04. DESIGN PROPOSAL

PROPOSED SCHEME, FIRST FLOOR LEVEL

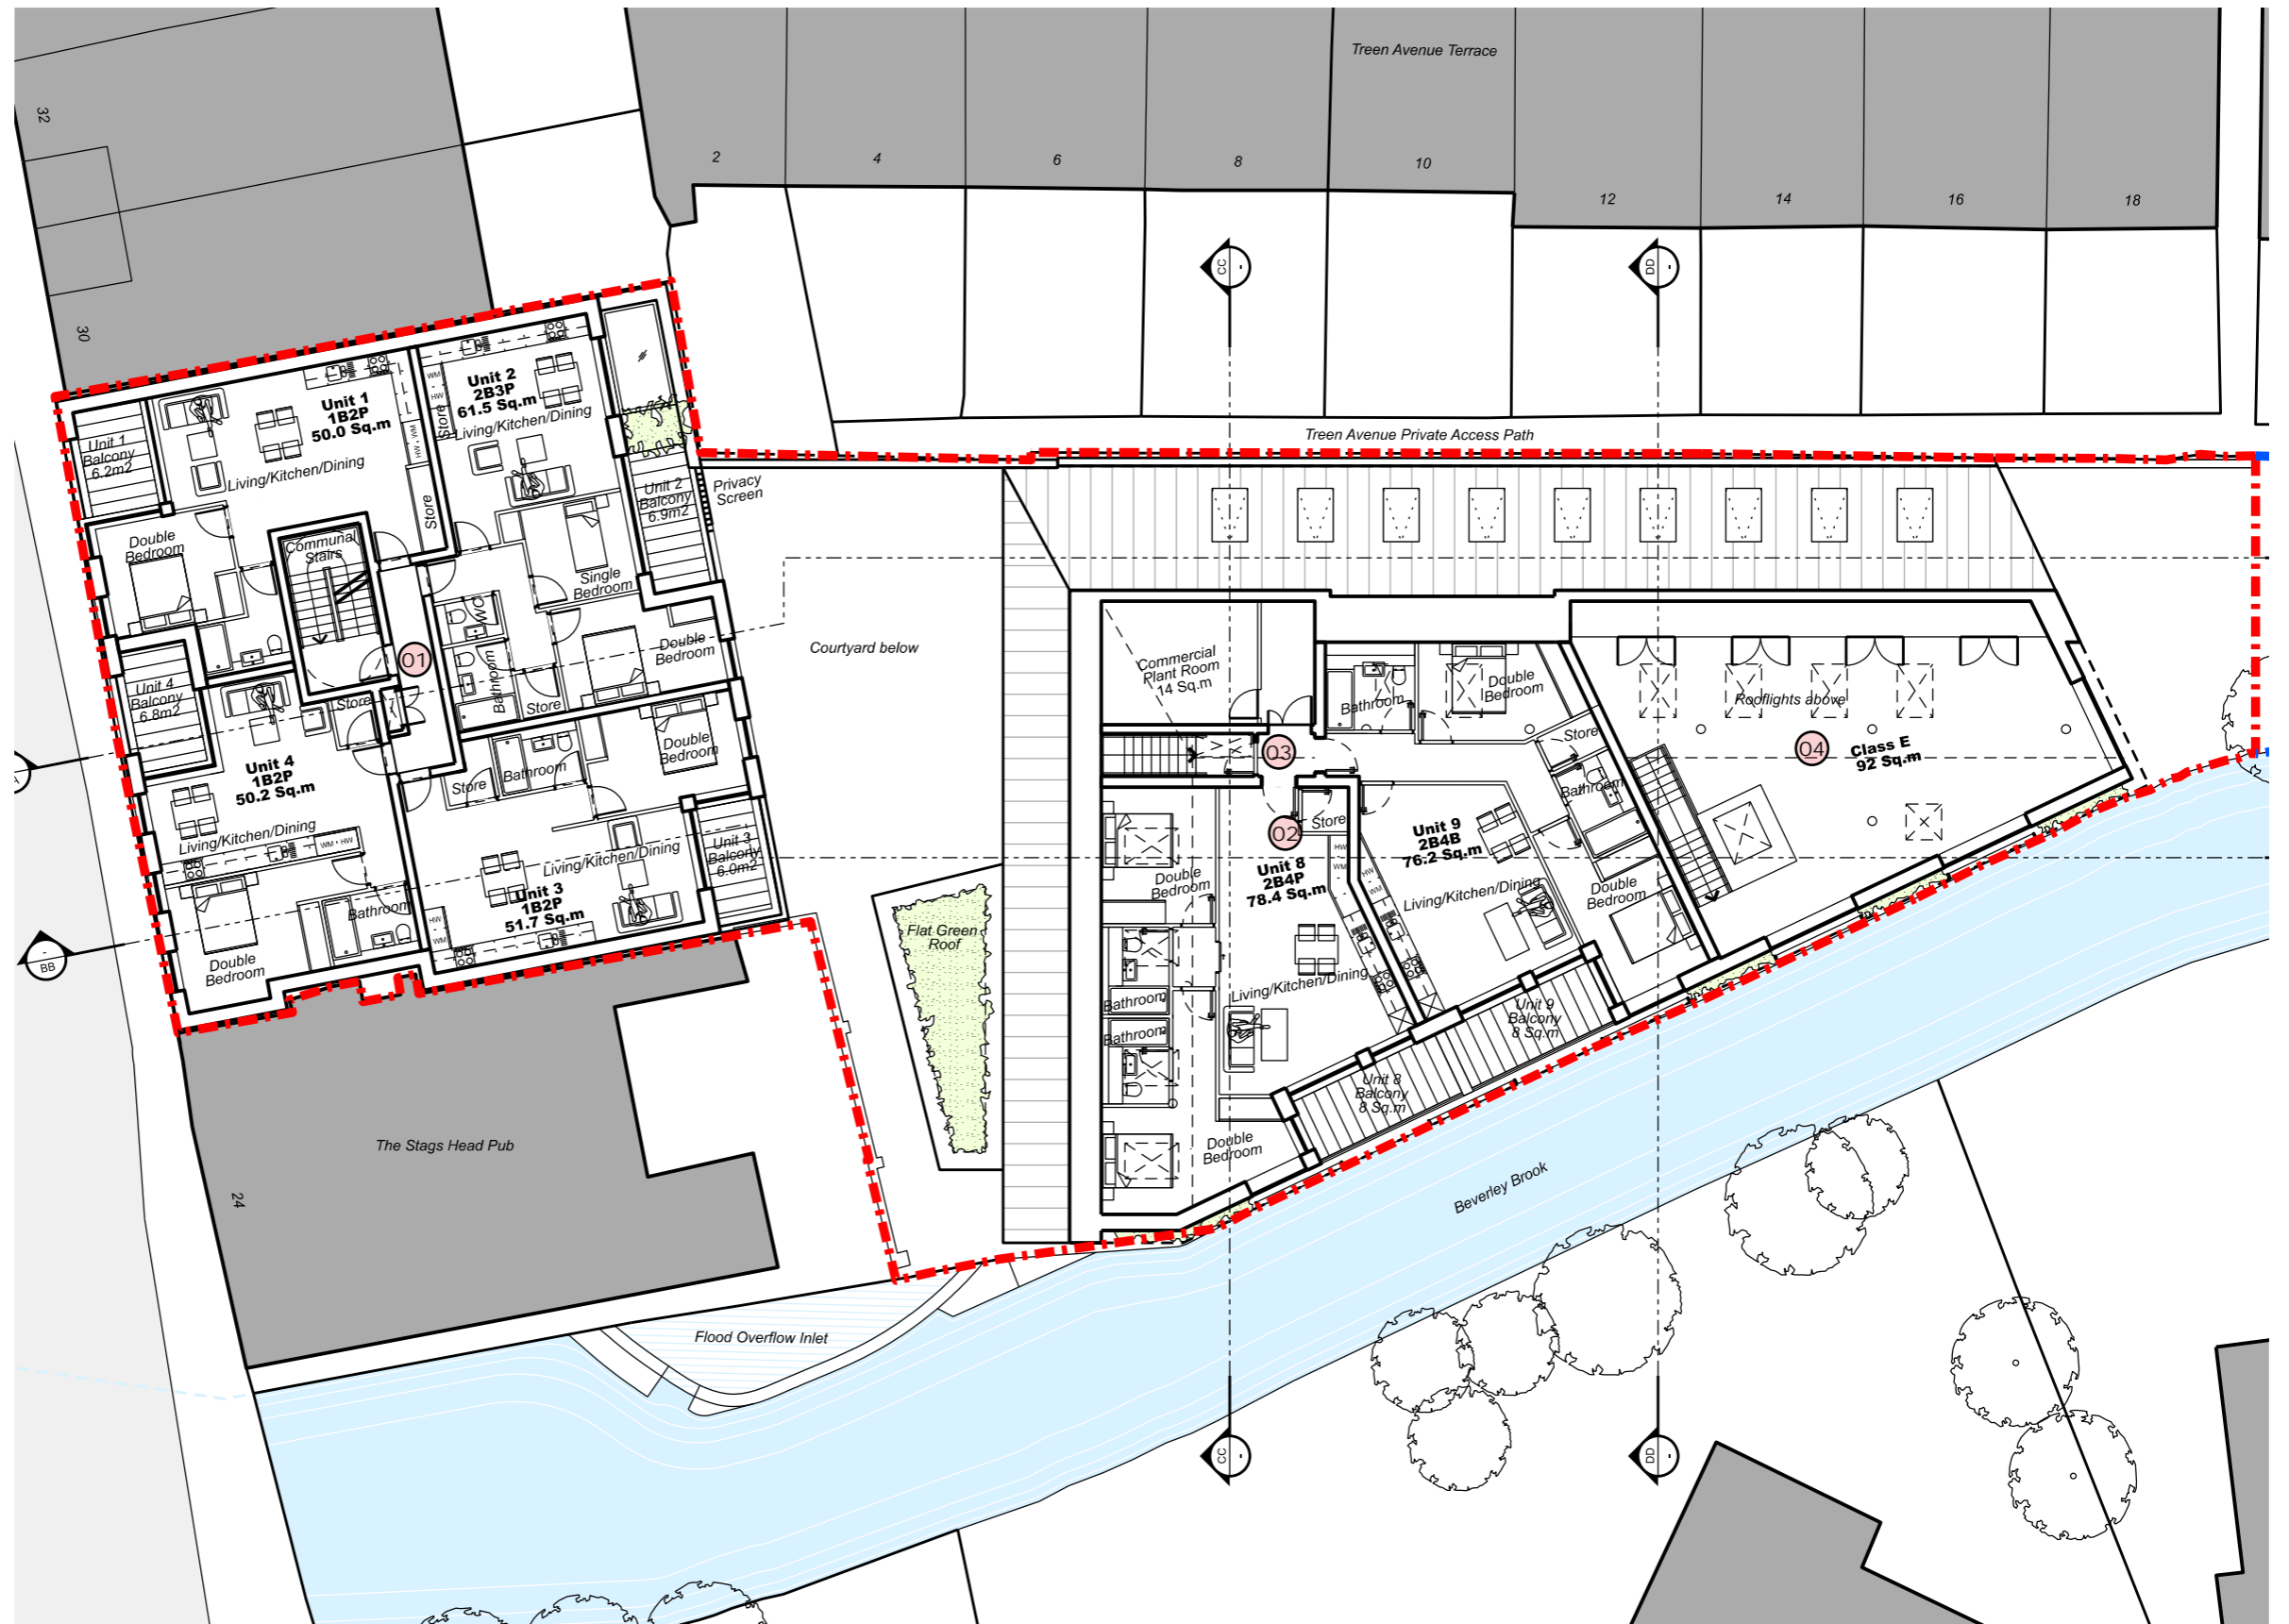
01 Protected lobby included to fire escape stairs and residential internal layout of units improved in order to comply with fire regulation.

02 Part of the commercial space to be used as residential. A total of 2 x 2B4P units.

03 New shared stair core to serve commercial plant room and the two proposed units.

04 Commercial layout amended including plant room, lift and stairs.

PROPOSED SCHEME, SECOND FLOOR LEVEL

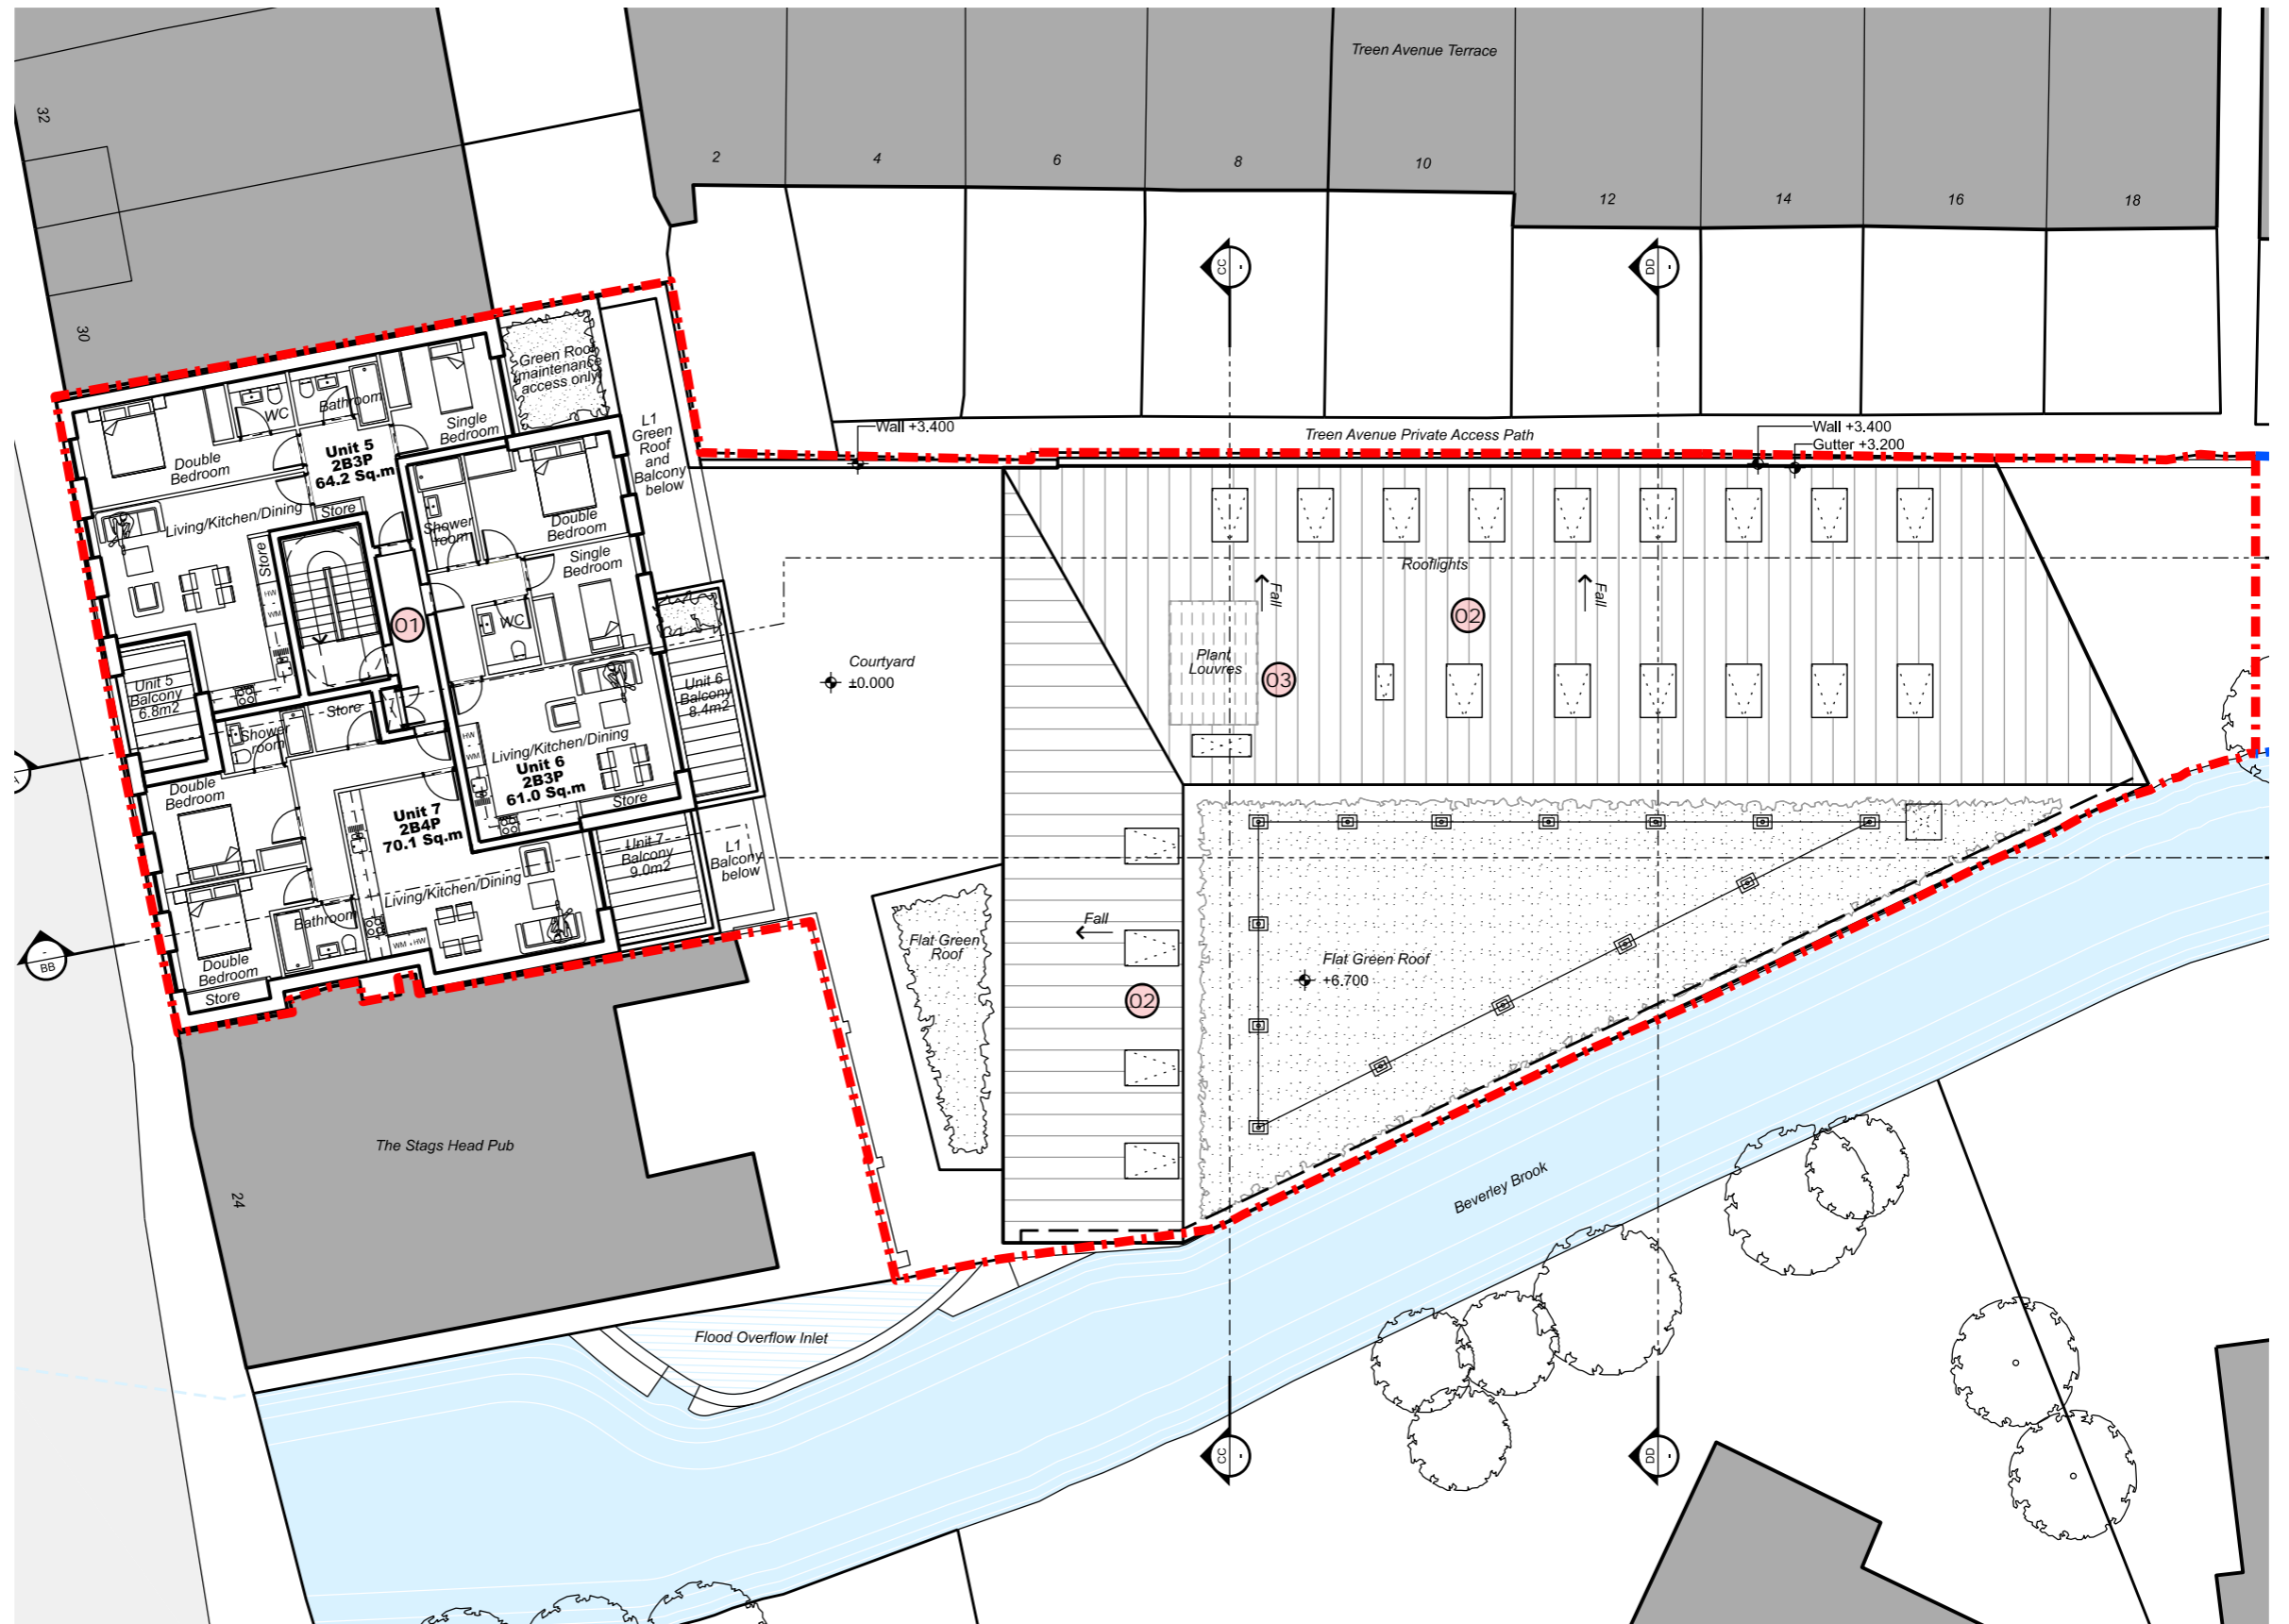
01 Protected lobby included to fire escape stairs and residential internal layout of units improved in order to comply with fire regulation.

02 New rooflights and previous location amended according to changes on internal layouts.

03 New location for commercial plant room.

PROPOSED SCHEME, ROOF LEVEL

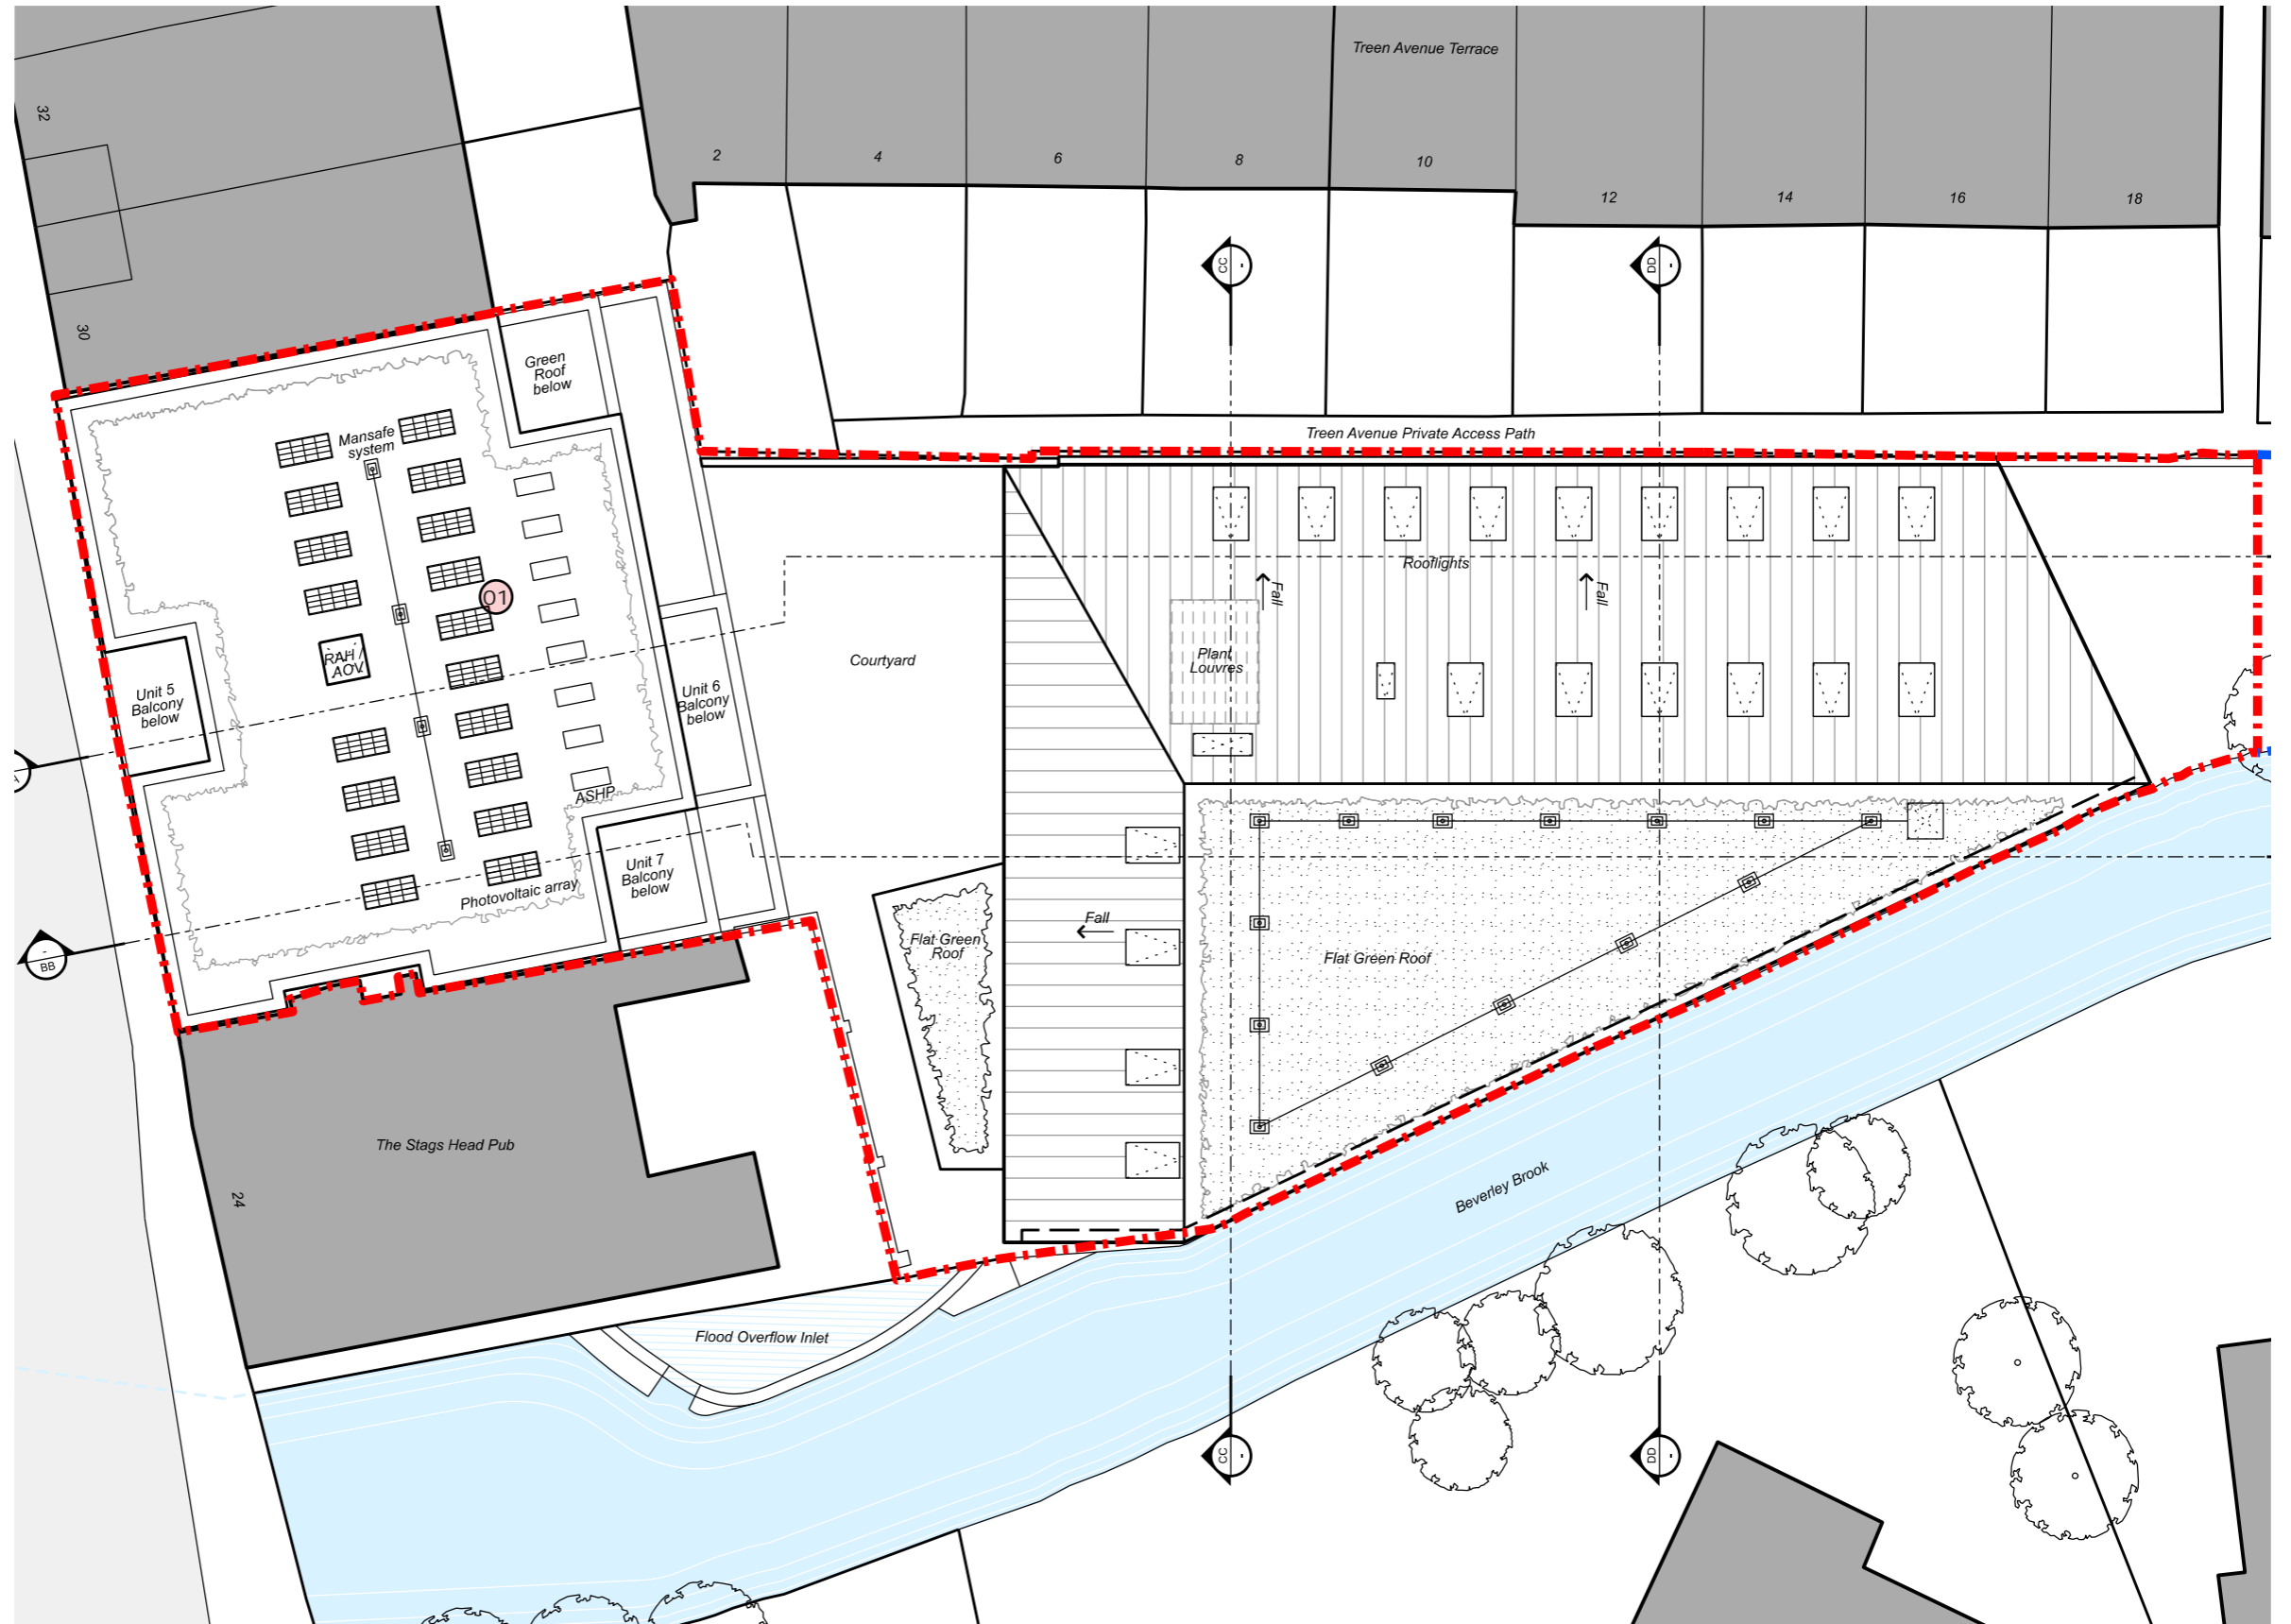
① Number of PVs have been reviewed and air source heat pumps added at roof level.
